RE: **Rain Tunnel Car Spa**
5401 Sevilla Ave
Grading and Drainage Plan
Engineer's Stamp Date 5/17/17 (File: F11D016)

Based upon the information provided in your submittal received 5/18/17, the Grading and Drainage Plan cannot be approved for Administrative Amendment to the Site Plan for Building Permit until the following comments are addressed:

DATE: 5/17/2017	sheet- C1.1
SCALE: AS NOTED	of 2

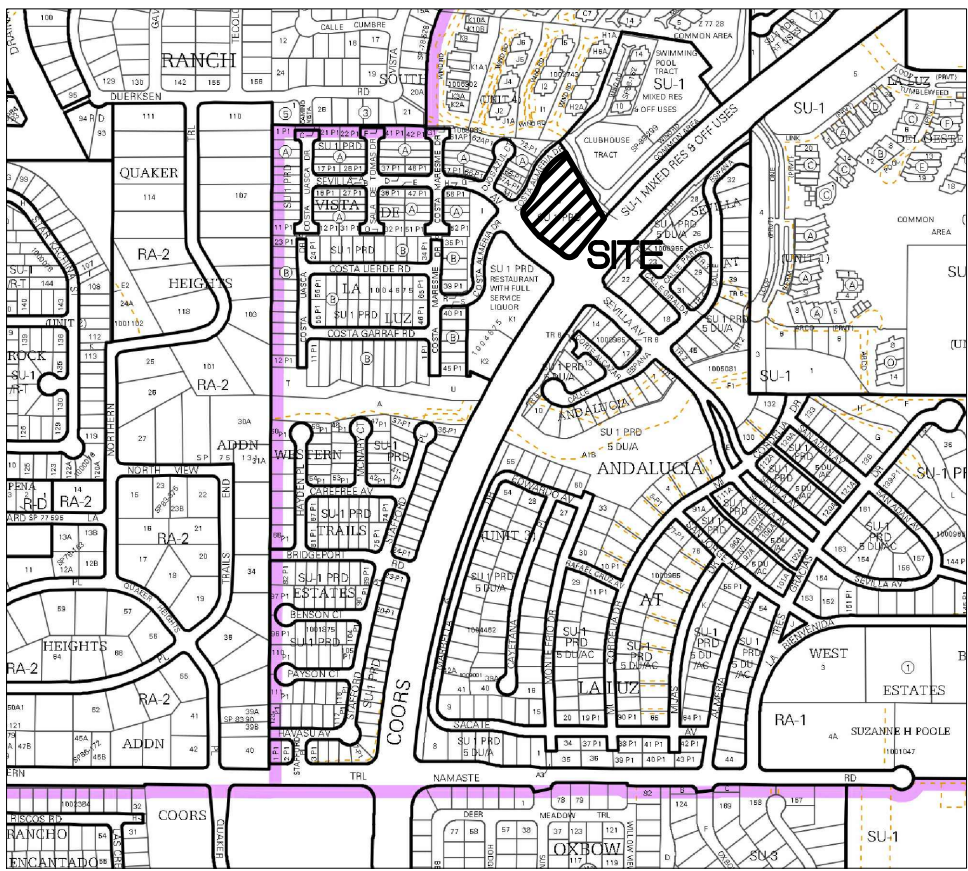
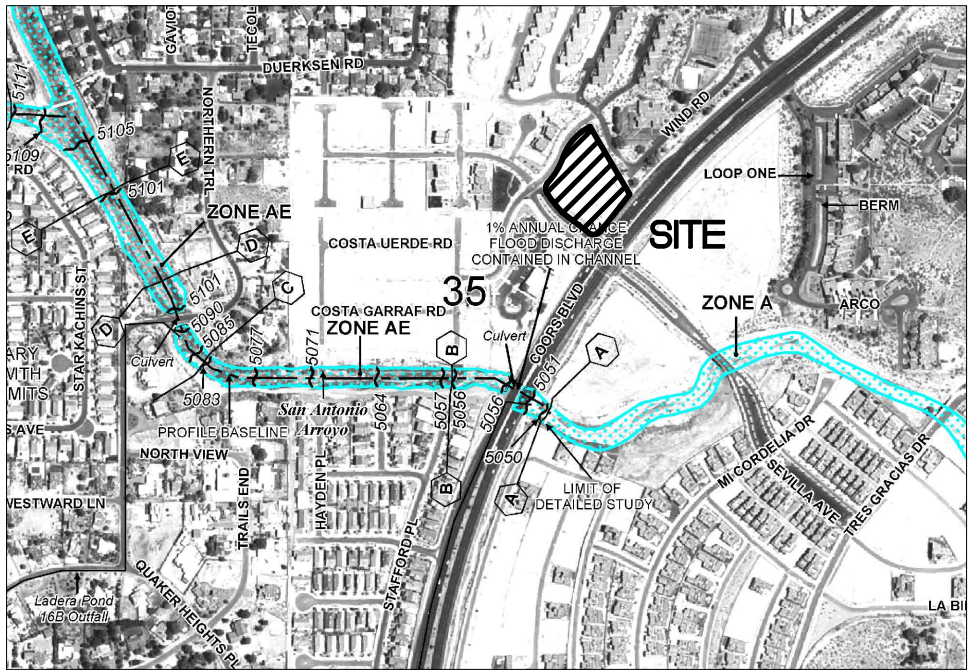
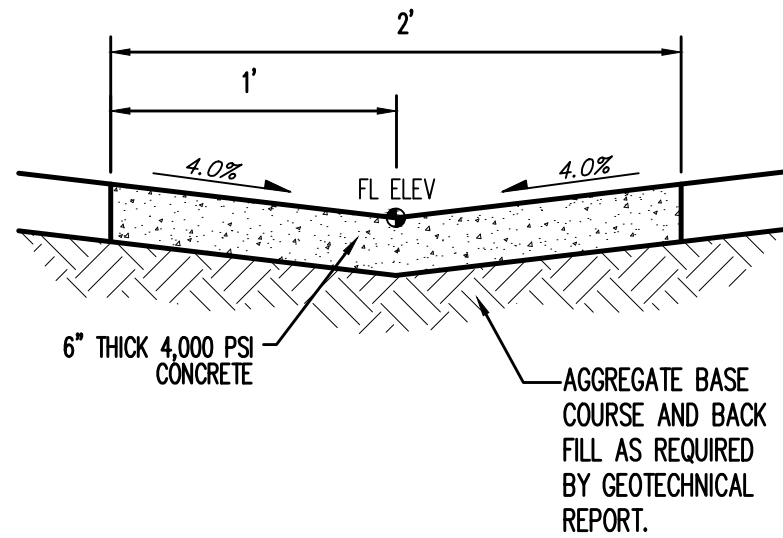
1. Provide details for the tie-in to the existing double-D inlet, including invert in/out, grate, and any required adjustments.
2. Provide details for pond outfall, including the outlet structure and pipe. Include flow, velocity, and HGL with the pipe profile.
3. The Grading and Drainage Plan for Site Plan for Building Permit needs to be clearly labeled as 'Not For Construction.'

1. Provide confirmation from the NMDOT's Drainage Section that the stub can still be used for this project under the new proposed conditions. Previous discussion required a water quality inlet for floatables and sediment, located where it could be easily accessed for maintenance.
2. Provide the structural engineer's detail sheets for the retaining wall adjacent to Coors, including wall calculations for saturated conditions due to the detention/retention pond.

3. The detention/retention pond will need a private drainage covenant for maintenance responsibility.
4. Provide finished floor elevation for the retailer at the south end of the lot.
5. This work requires an updated Erosion and Sediment Control Plan to be submitted to the storm water quality engineer (Curtis Cherne, PE, ccherne@cabq.gov).
